SERVICE BULLETIN

POWER PLANT - NACELLE - EXHAUST - STAINLESS STEEL GUIDE PADS, NO. 1 OPEN LATCH INDICATOR, THRUST REVERSER - ADDITION OF - CATEGORY CODE 8 - MOD.NAC-71-0137

V2500-NAC-71-0137

No. 1 Latch Open Indicator Guide Pad Installation
Fig.1

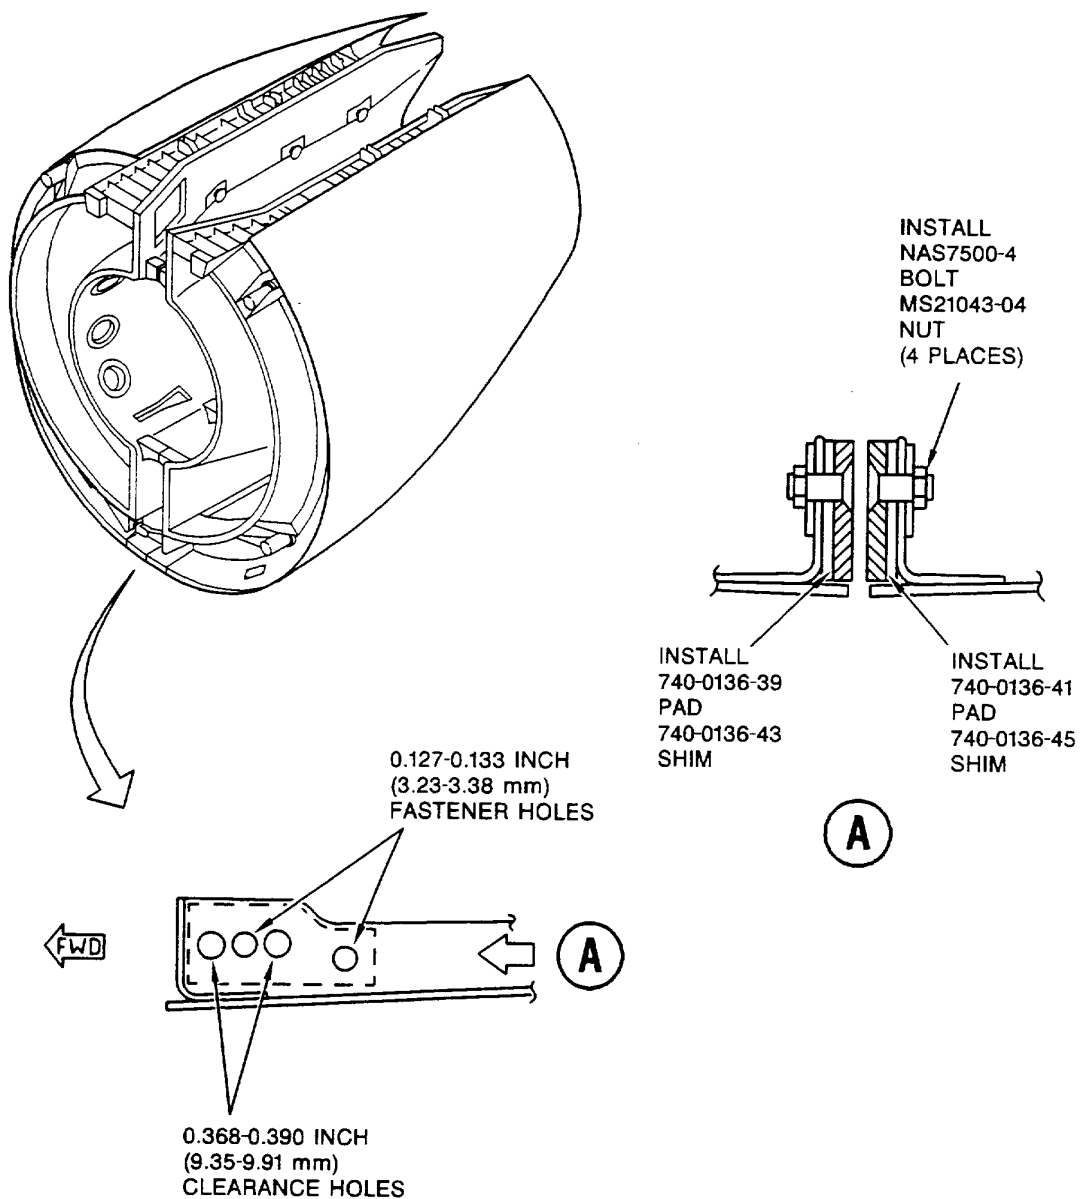
Install stainless steel guide pads on the thrust reverser to provide a smooth guide path for the indicator and reduce lateral movement to prevent jams and false open indications.

Stainless steel guide pads for the No. 1 latch open indicator are installed on the thrust reverser halves.

- (c) Put the shims and pads into position on the thrust reverser lower track and backdrill two 0.156-0.163 inch (3.96-4.14 mm) holes through the lower track. Refer to Figure 1.

- (d) Temporarily install the pads and shims on the thrust reverser halves with NAS7500-04 screws and MS21043-04 nuts.
- (e) Adjust the clearance between the latch open indicator and the pads when the thrust reverser and engine are installed on the aircraft. Refer to A320 Aircraft Maintenance Manual, Chapter 78-32-01 and 78-32-03.
